Docket Item # 6
BAR CASE #2008-0235

BAR Meeting
July 8, 2009

ISSUE: Alterations and Signage

LOCATION: 134 North Royal Street (Gadsby's Tavern)

Figure 5: Archaeology Limits of Disturbance

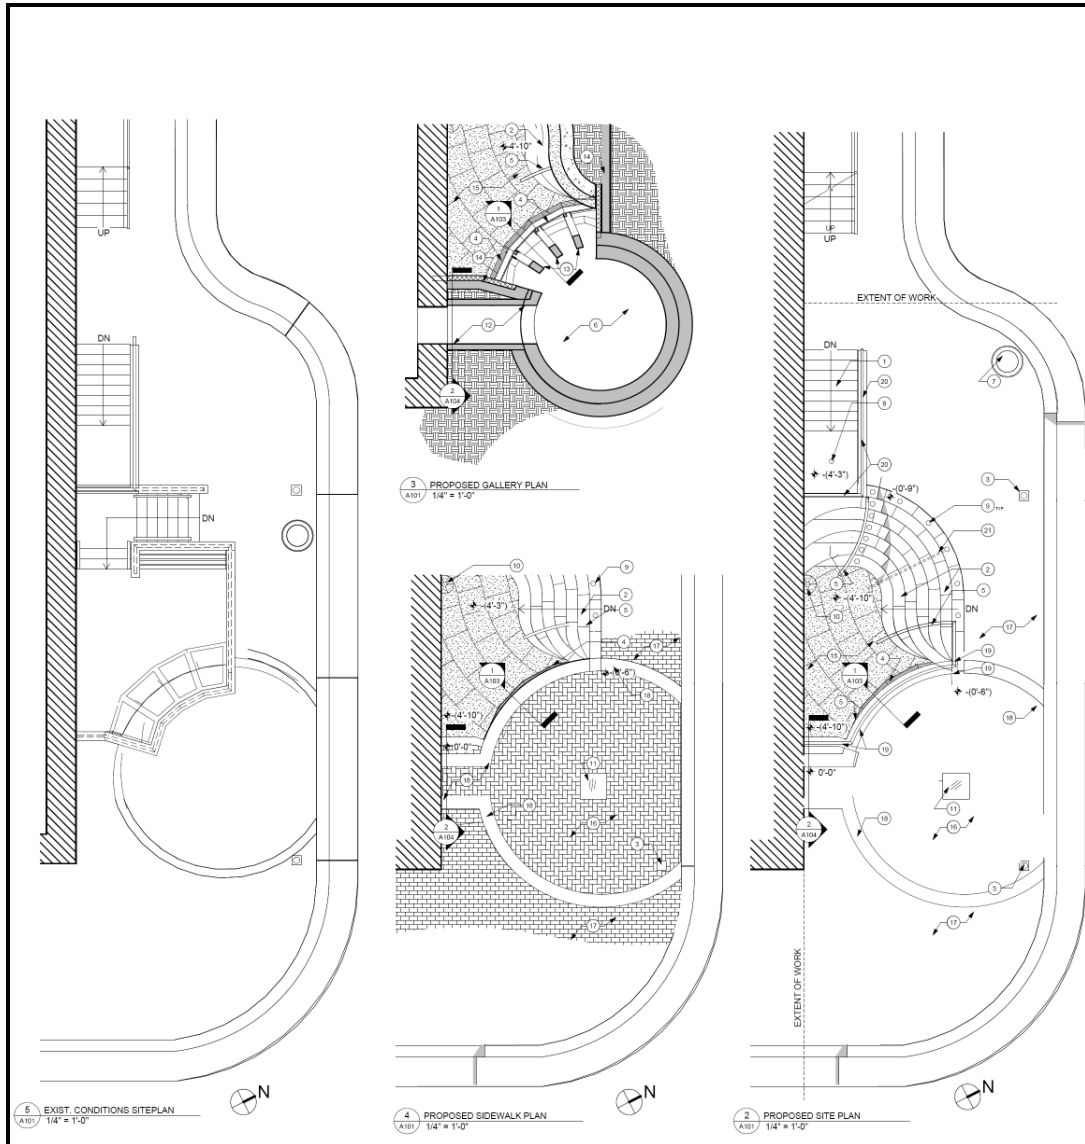
The proposed design will have very minimal impacts to undisturbed earth. The applicant has provided a drawing indicating the Limits of New Disturbance for the project (see figure 5.) The shaded area in the drawing indicates where the applicant proposes to cut into earth that has not already been previously impacted. As shown, these areas are very minimal, and will be monitored by City Archaeology Staff.

The applicant only proposes to excavate a very small area which has not been previously impacted. The remaining project will be undertaken on the existing site’s footprint. As shown in the recommended conditions, the City Archaeology staff proposes to monitor all phases of the project to ensure the project maintains conformance to the strict Limits of Disturbance (LOD) and footprint.
